# Service Bulletin

20-036

## **Rattling from the Front of the Vehicle**

RUBBER DAMPER CAPS

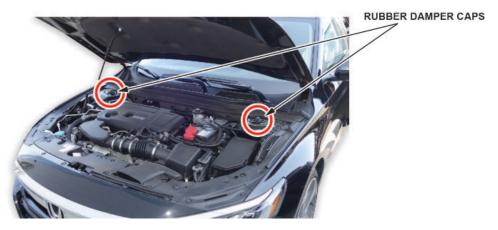
Remove the rubber damper caps, then test-drive the vehicle.

- If you no longer hear a rattling from the front of the vehicle with the caps removed, go to REPAIR PROCEDURE.
- If you still hear a rattling from the front of the vehicle with the caps removed, this bulletin does not apply. Continue with normal system troubleshooting.

1. Install the new rubber damper caps on both sides.
